**RE: Steep Slopes Application for the Danziger Residence,
220 Mt. Hope Blvd, Hastings-on-Hudson, NY**

Subject : Steep Slopes Review
220 Mt. Hope Blvd.
Village of Hastings-on-Hudson, NY

**Drawings
Reviewed** : "Site Plan", Revised 8/3/16, Sheet S-1.
"Slope Analysis & Cross Section", Revised 8/3/16, Sheet S-2.
"Planting Plan & Details", Revised 8/3/16, Sheet S-3.
"Stormwater Pollution Prevention & Erosion Control Plan",
Revised 8/3/16, Sheet S-4.

Project	Sheet
Date APRIL 2, 2016	S-1
Scale 1" = 10'-0"

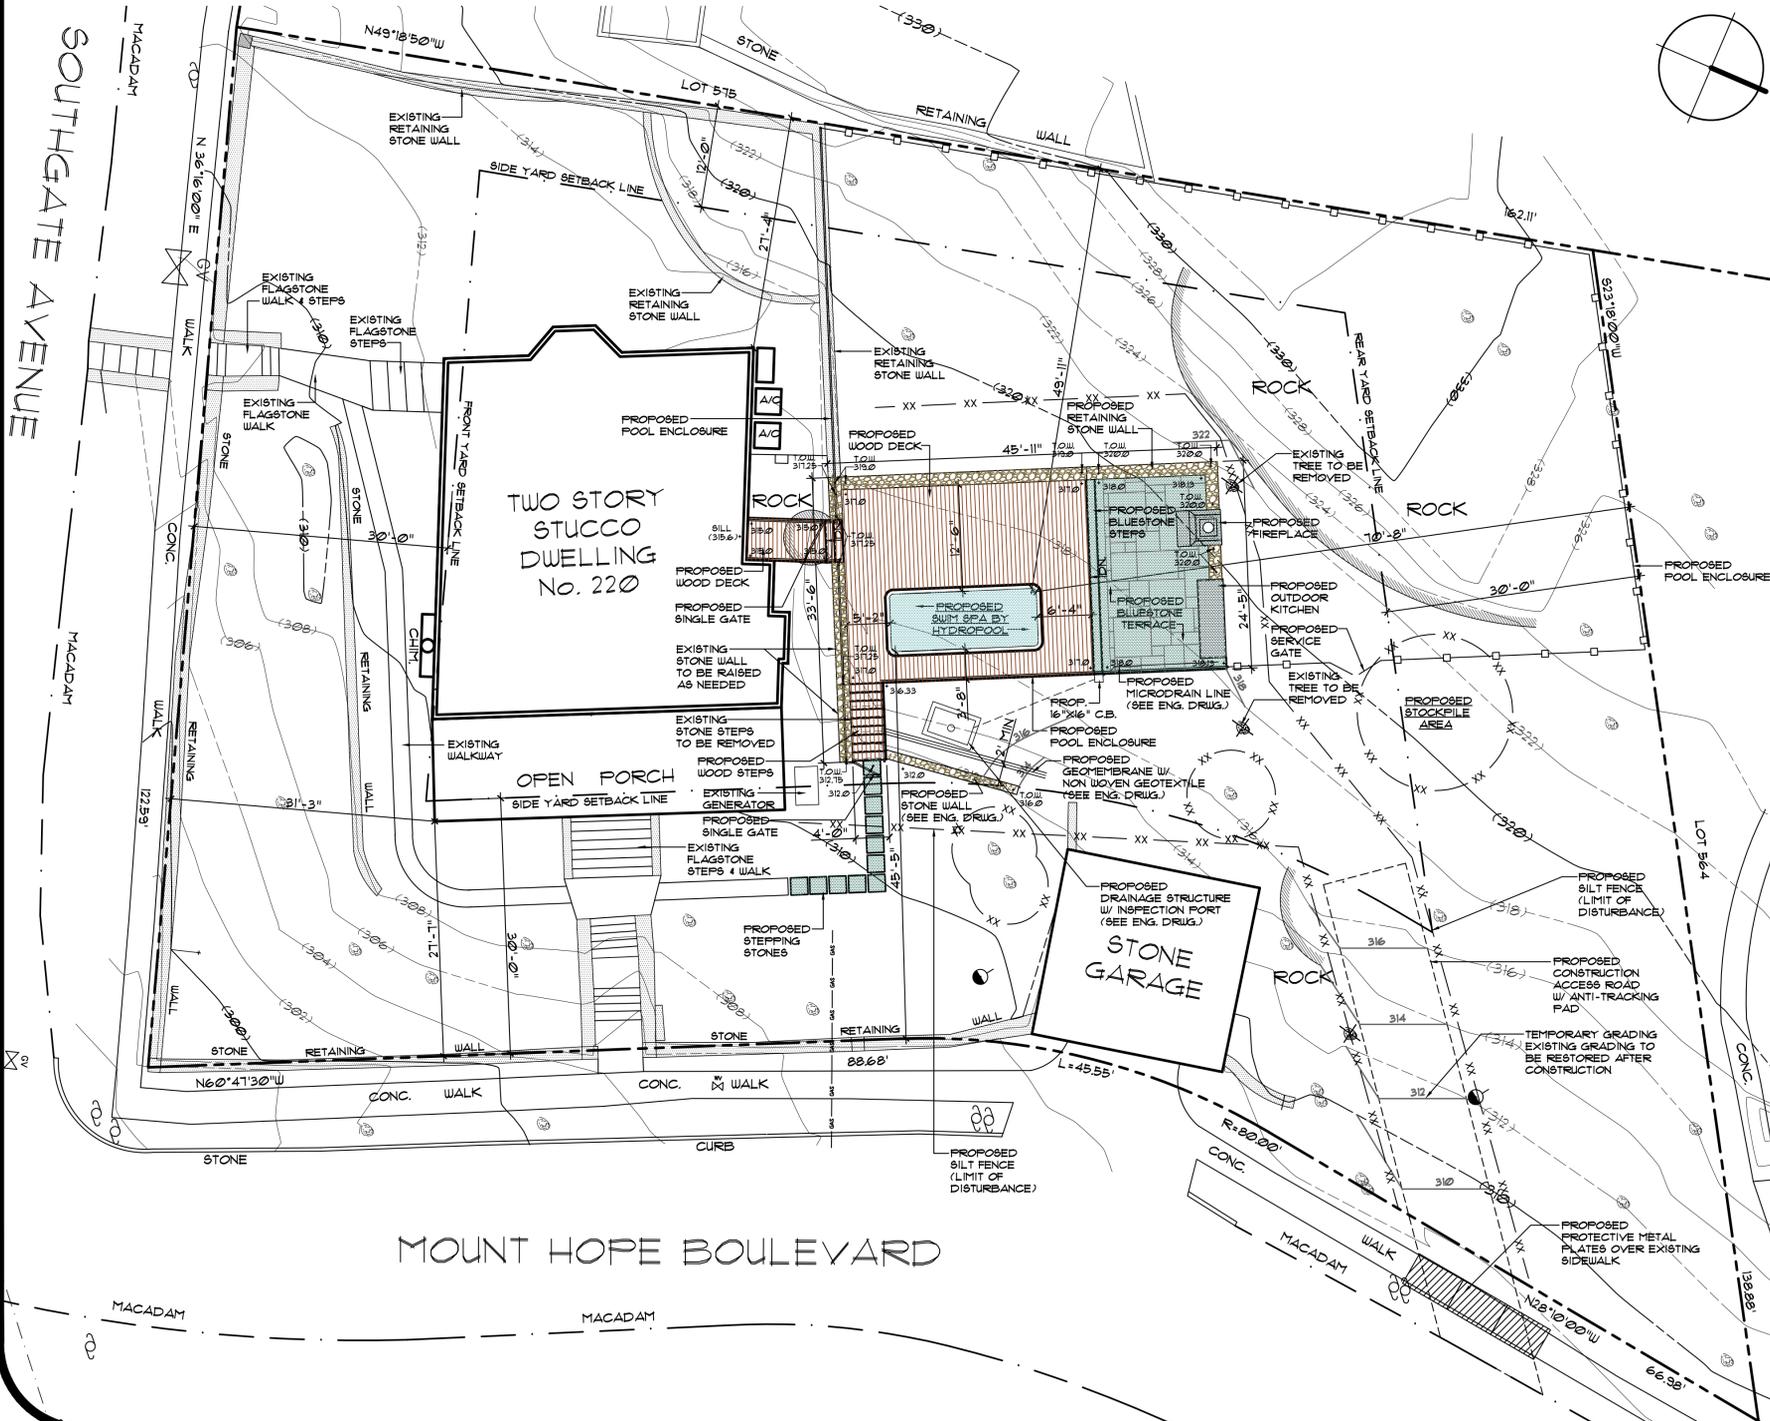
1. The temporary grading along the construction access road is shown as well as a note calling to restore existing grading after the construction will be completed. Any disturbed areas will be fine graded and seeded after the construction access road will be removed.

7. The area of disturbance is delineated with a silt fence on sheets S-1 (Site Plan) and S-4 (Stormwater Pollution Prevention & Erosion Control Plan)
8. The name and address of the surveyor is indicated in general notes on sheets S-1 (Site Plan) and S-2 (Slope Analysis & Cross Section). Surveyor stamp was added to S-4 plan.

17. The remaining requested notes are shown on Site Plan (S-1) under "Additional Notes"

CONSTRUCTION ENTRANCE DETAIL
N.T.S.

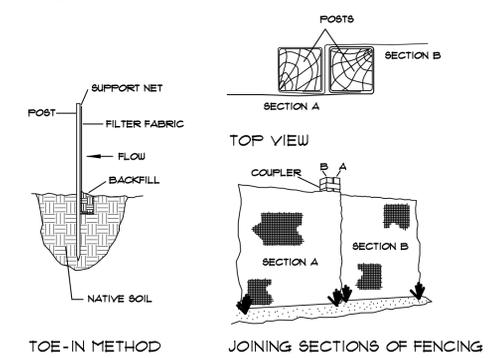
15. The construction entrance detail on the drawing S-1 was changed to match the detail from the drawing S-4
16. The note regarding cut /fill material was added to the sheet S-2 (Slope Analysis & Cross Section)

RETAINING STONE WALL / BLUESTONE TERRACE / POOL FENCE DETAIL

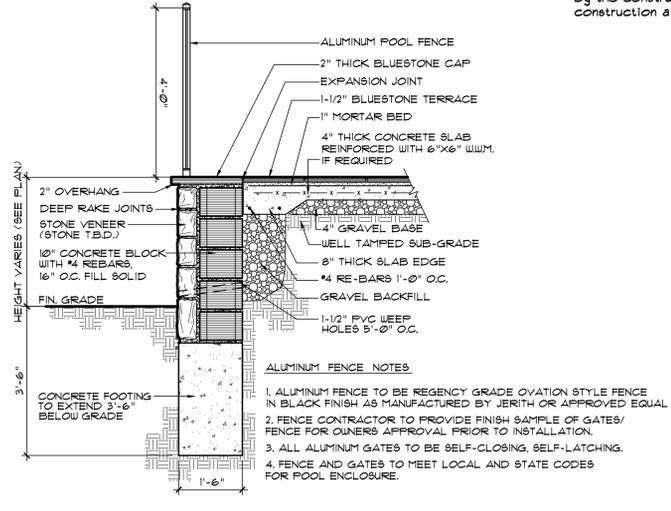
6. The construction detail of the proposed stone wall and the fence is shown in detail "Retaining Stone Wall / Bluestone Terrace / Pool Fence Detail" on sheet S-3. The proposed elevations of the retaining walls, wood deck and bluestone terrace are indicated on the plans S-1 and S-4.

CONCRETE PAVENET RESTORATION DETAIL

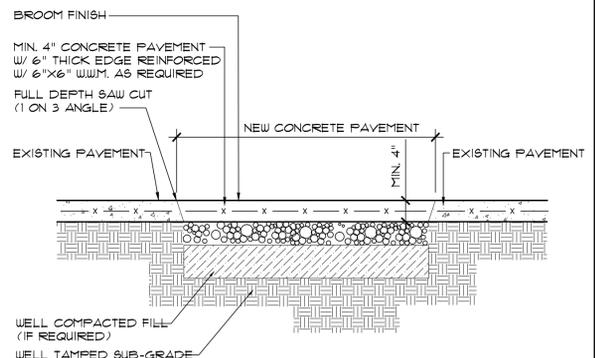
3. The plan is showing protective steel plates across the public sidewalk. If the concrete pavement will be damaged during the construction, it will be repaired as shown in "Concrete Pavement Restoration Detail" on sheet S-3

STORMWATER POLLUTION PREVENTION AND EROSION CONTROL PLAN

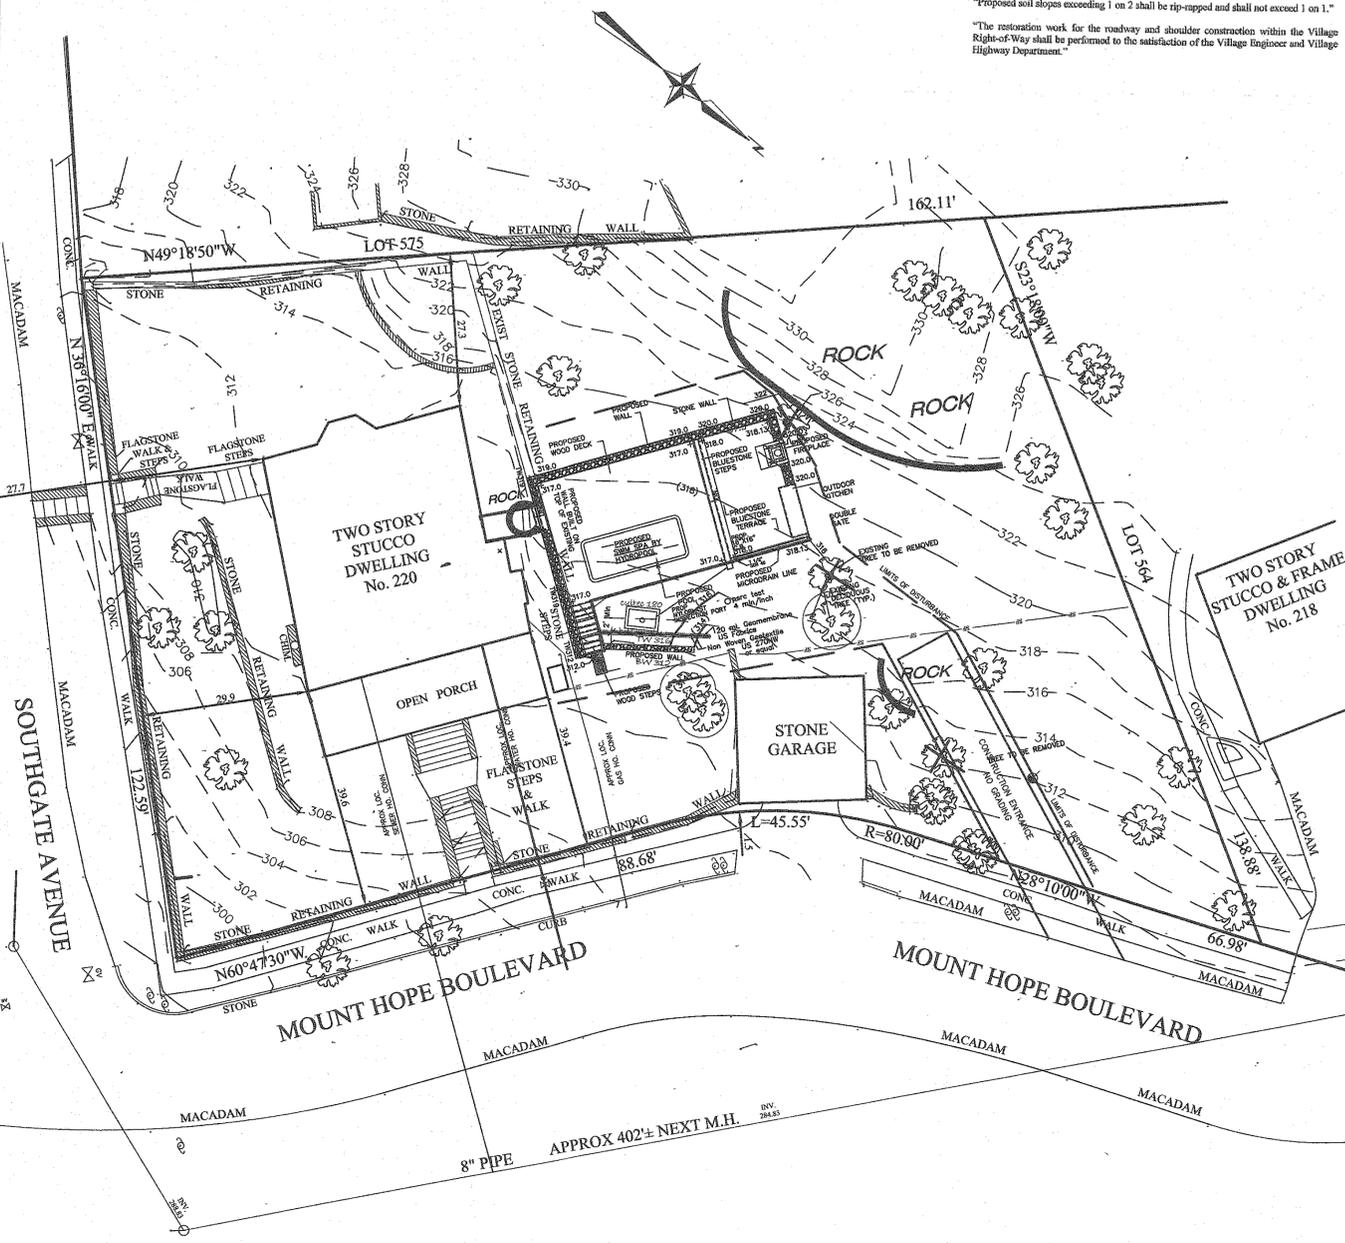
4. Stormwater Pollution Prevention & Erosion Control Plan (S-4) is showing a detail of the proposed catch basin.
5. The proposed improvements are now shown in color and are all labeled as "proposed".

9. The location of the percolation test was added to the sheet S-4.
10. The note was added to S-4 plan stating that the proposed infiltration system will not be connected until construction is completed and the site is stabilized.

13. The north arrow was revised on all drawings to match.
14. Plan S-4 (Stormwater Pollution Prevention & Erosion Control Plan) is now in larger (1"-10'-0") scale.
